THINK City Low Voltage Electrical Distribution System
For: **THINK Nordic AS**
DIAGNOSTIC (J1962) CONNECTOR SCHEMATIC

Size: B
FCSM No.:
DWG No.: THINK CITY LV EDS - 13

THINK CITY Low Voltage Electrical Distribution System
THINK CITY LV EDS - 18-1

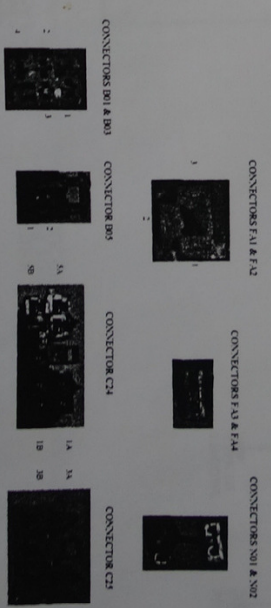
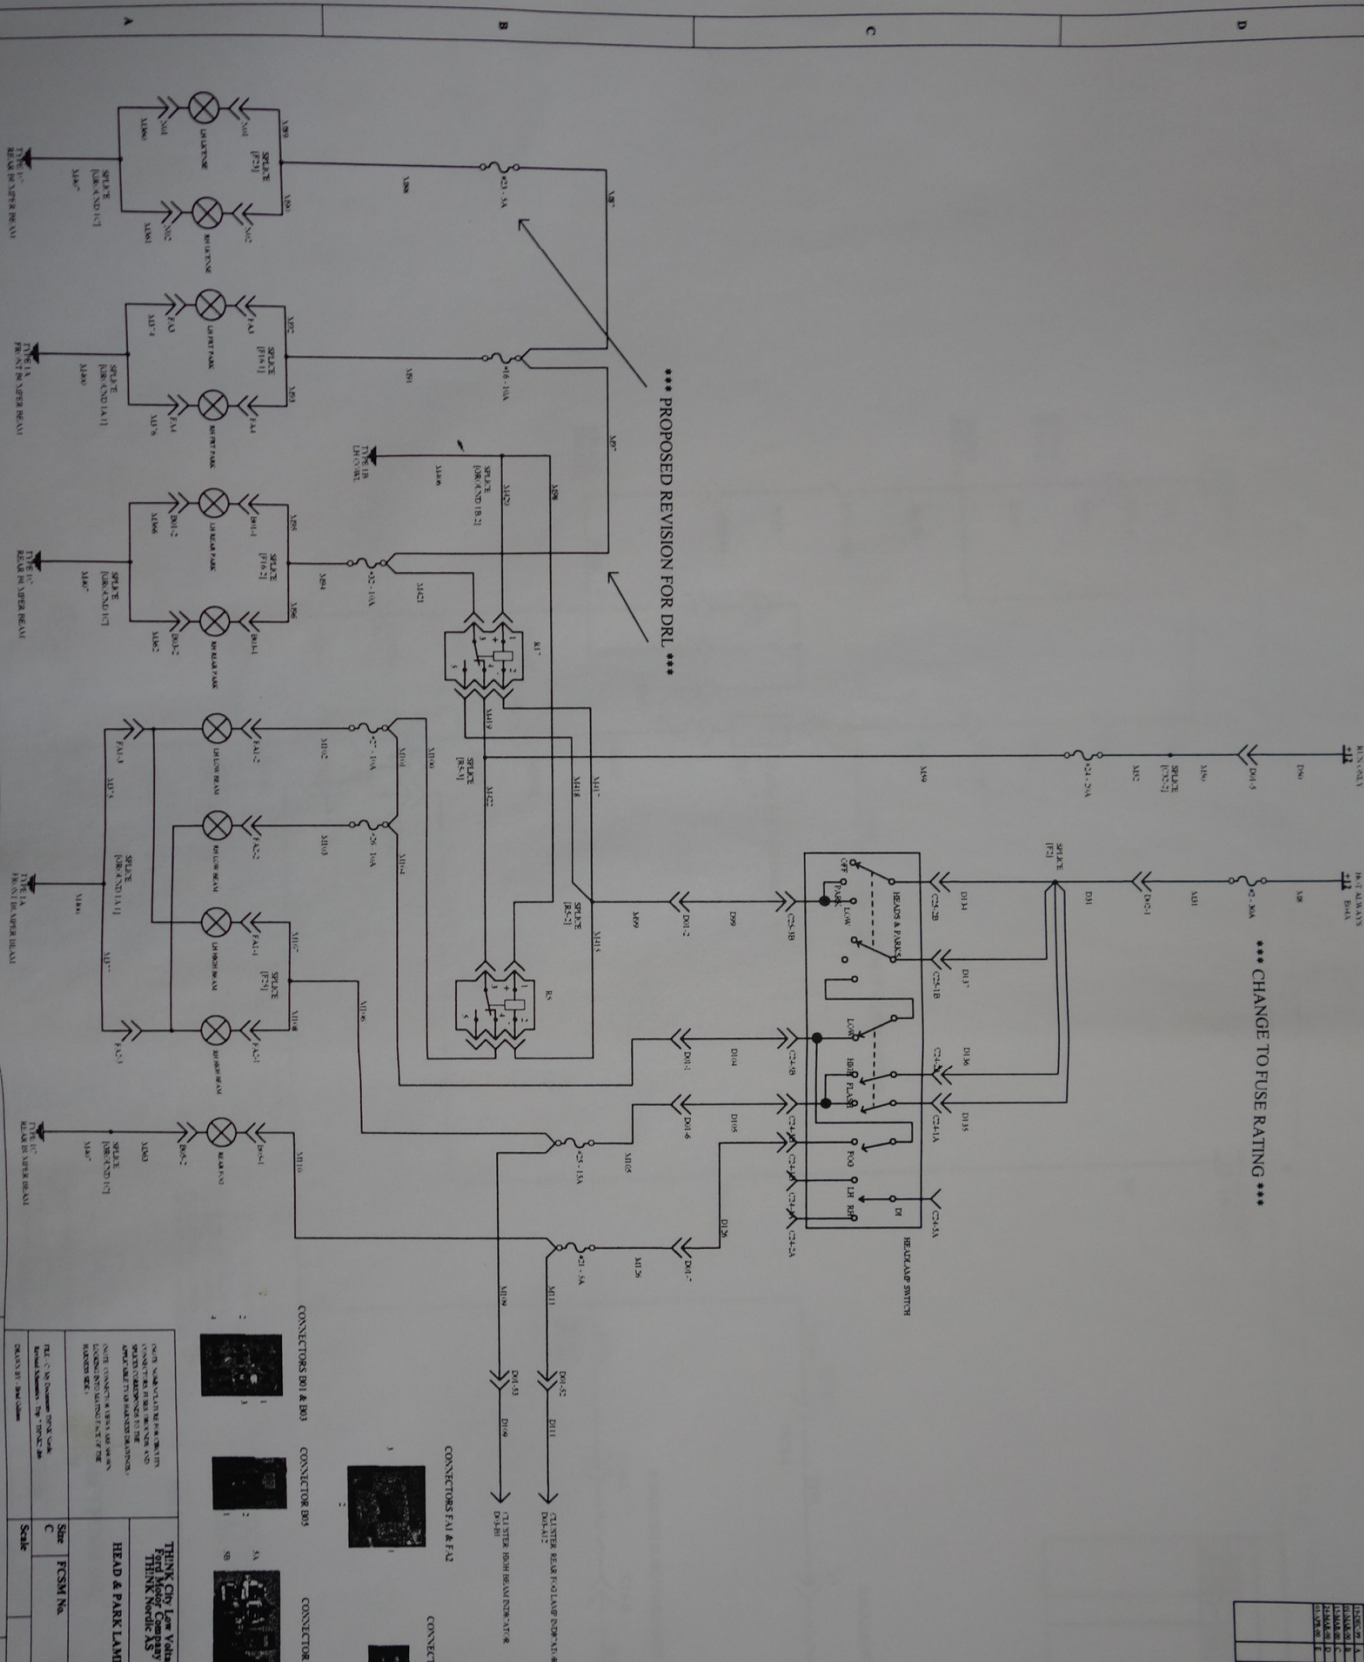
*** CHANGE TO FUSE RATING ***

*** PROPOSED REVISION FOR DRL ***

RADIO SCHEMATIC

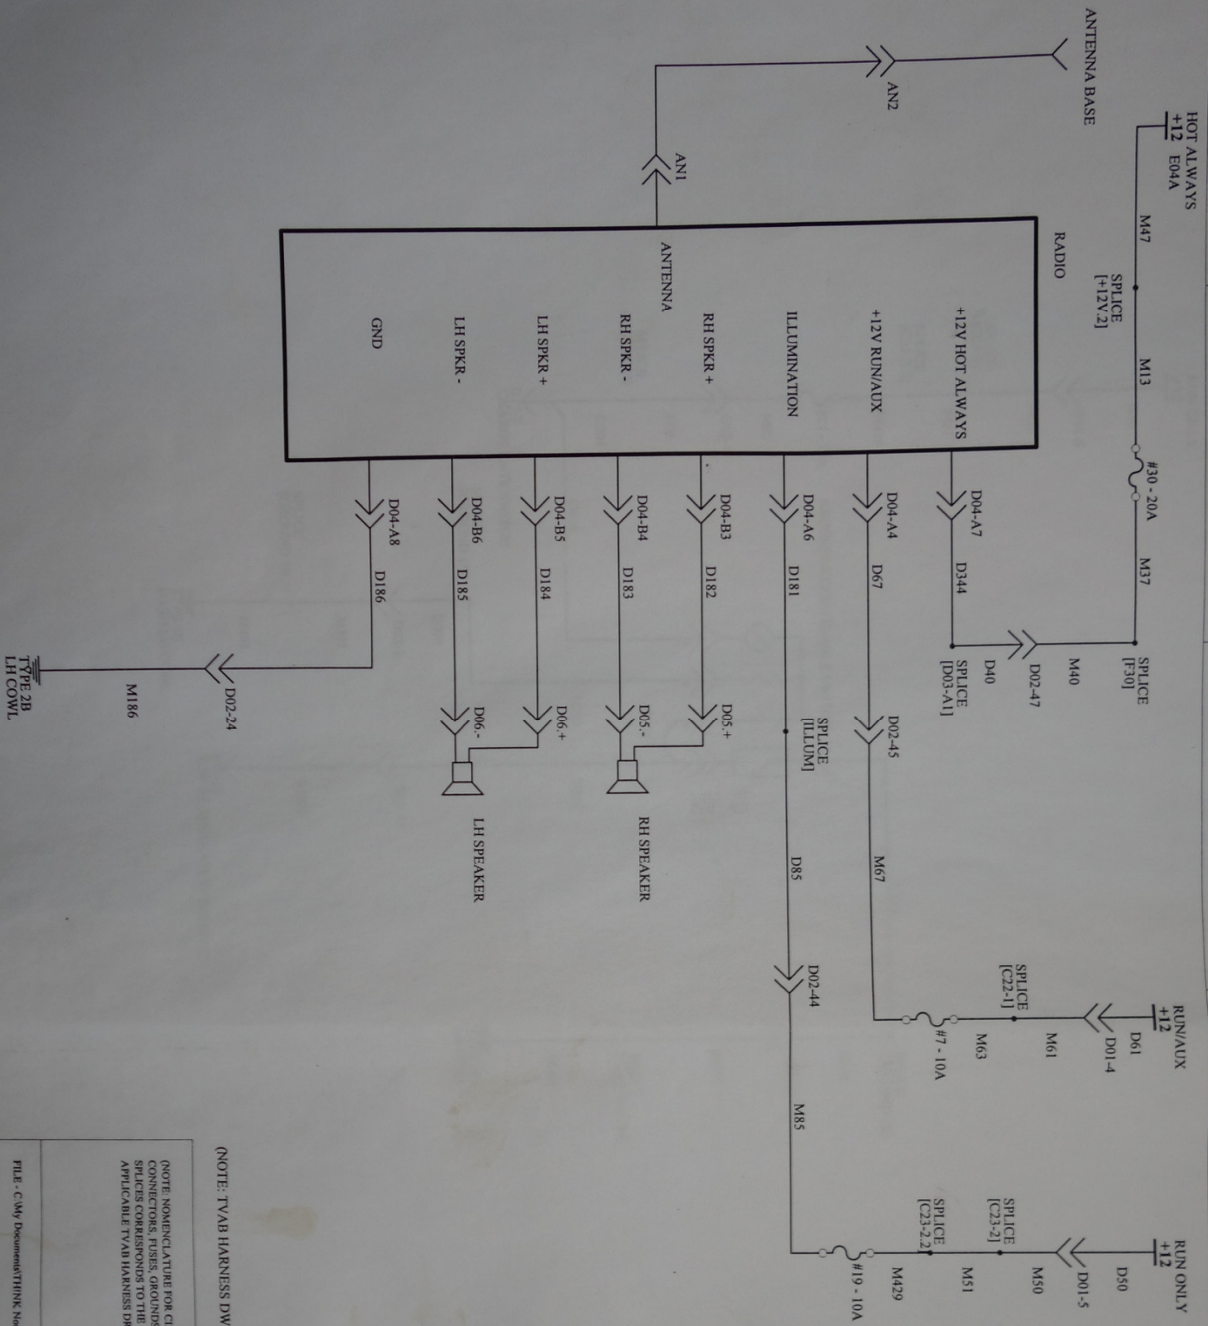
(NOTE: TVAB HARNESS DWG. DOES NOT REFLECT THE UPDATED CONNECTOR PIN-OUT.)

ACTIVE RESTRAINTS SCHEMATIC

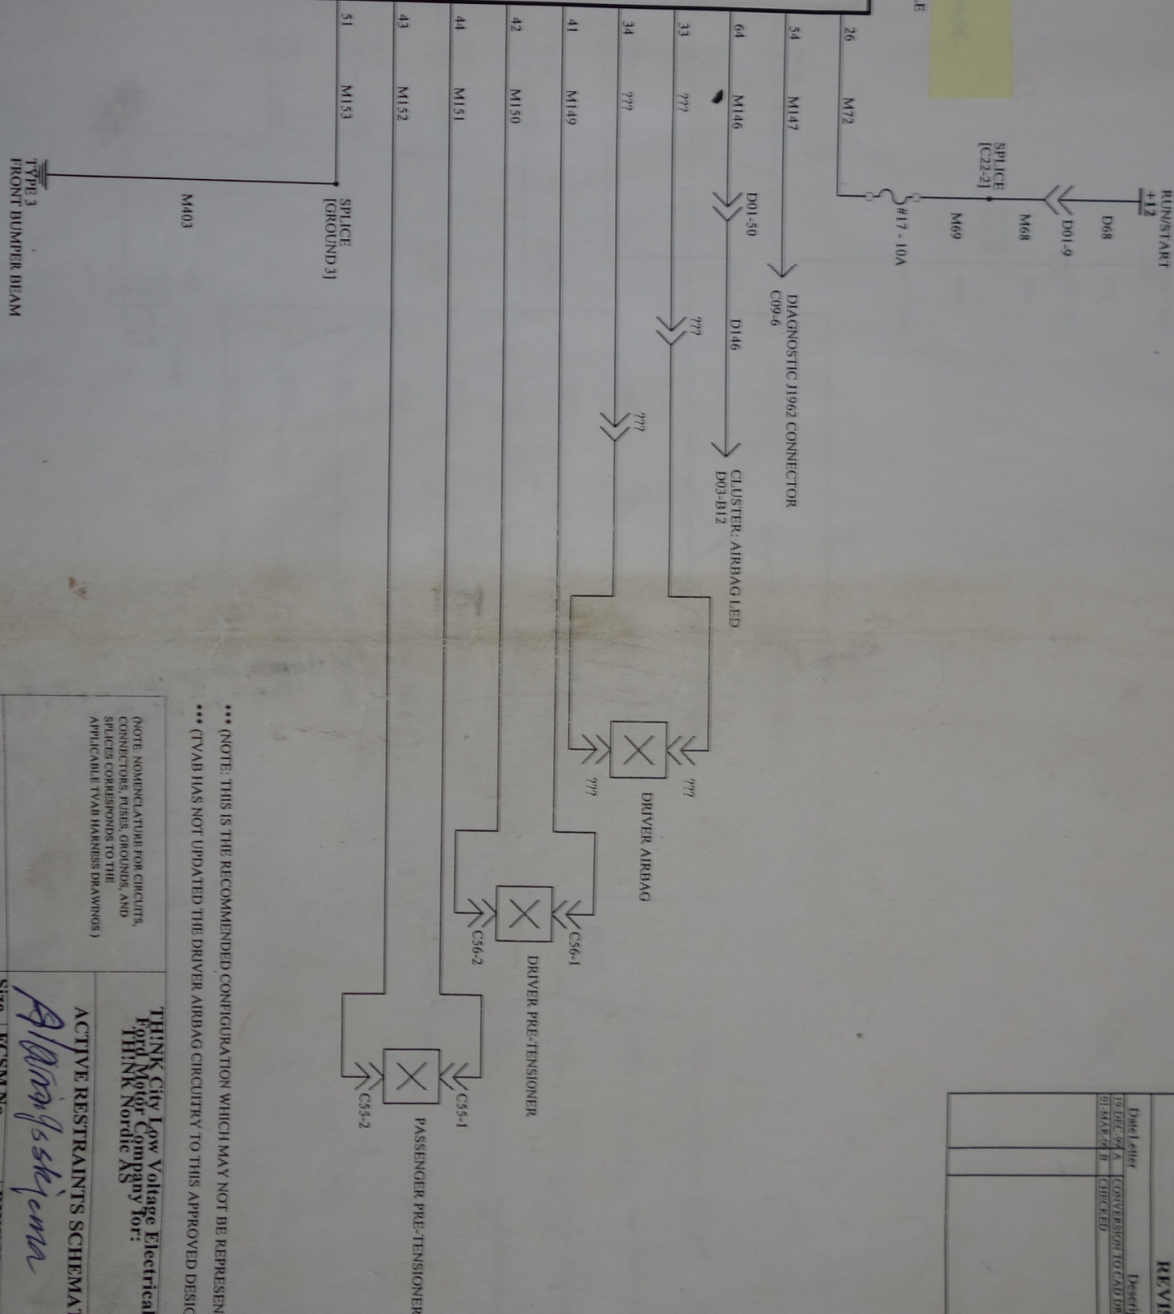
*** (NOTE: THIS IS THE RECOMMENDED CONFIGURATION WHICH MAY NOT BE REPRESENTATIVE OF PRODUCTION) ***
 *** (TVAB HAS NOT UPDATED THE DRIVER AIRBAG CIRCUITRY TO THIS APPROVED DESIGN) ***

CLIMATE CONTROL SCHEMATIC

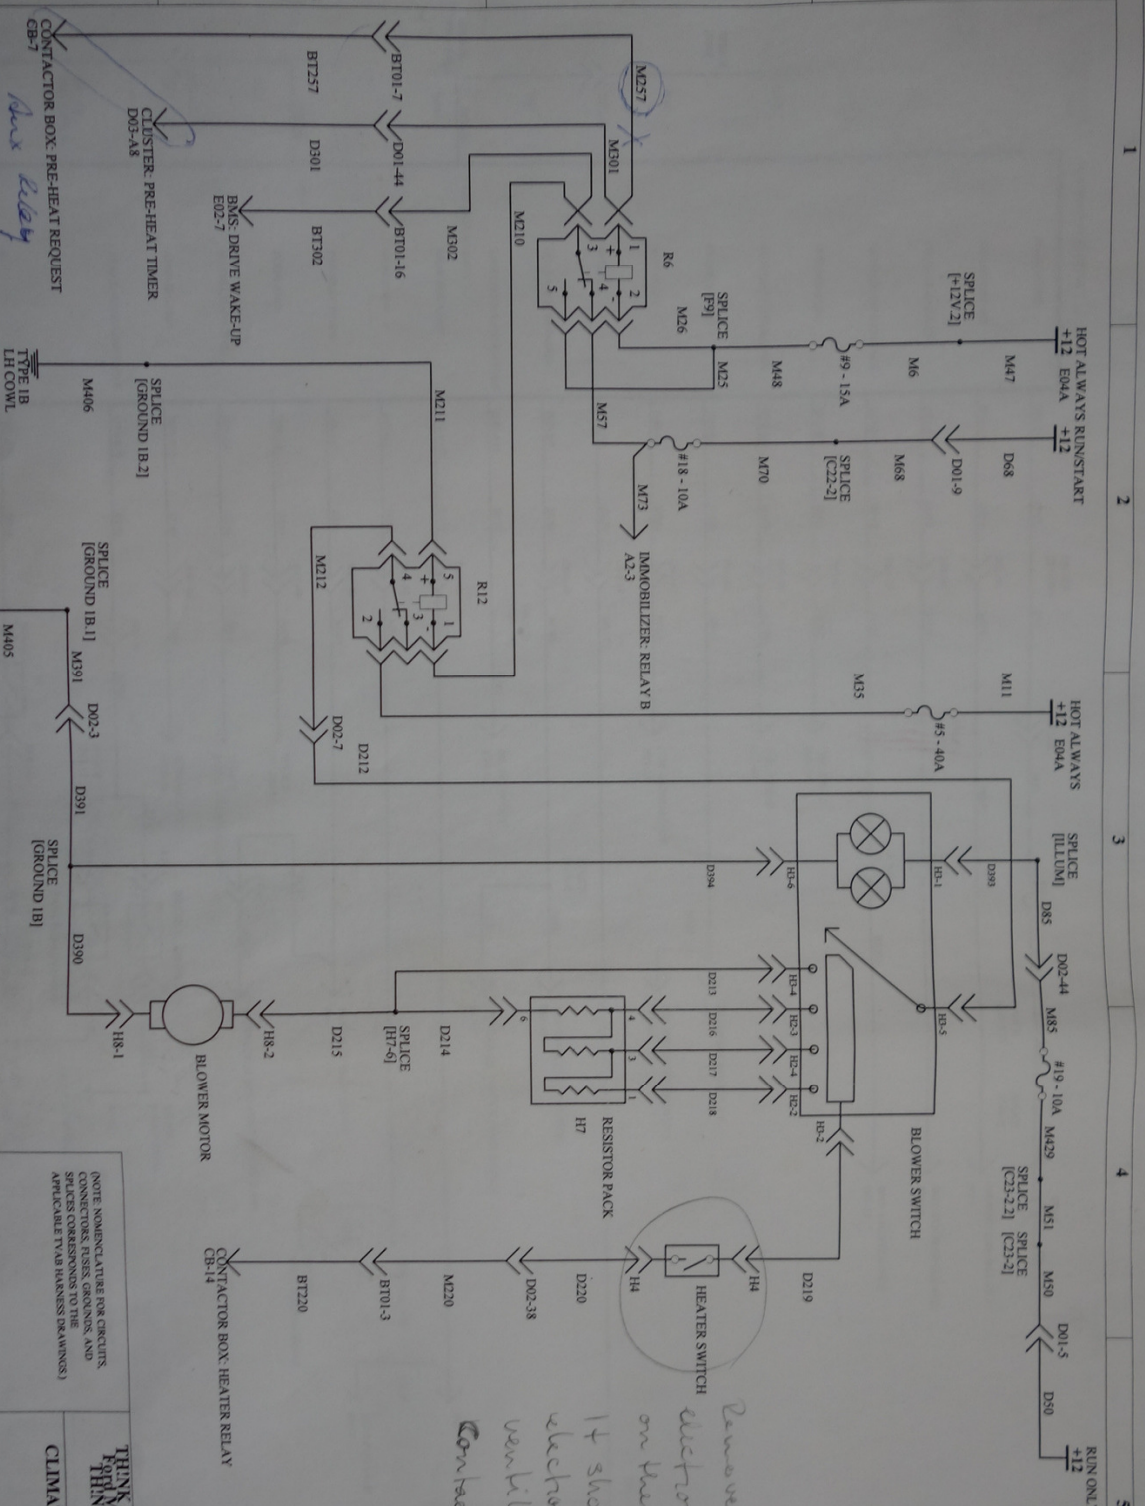
Remove and replace with electronic unit that senses voltage on the output from the fan switch. It should be included in the electronic control unit for the ventilation system or in the Controller.
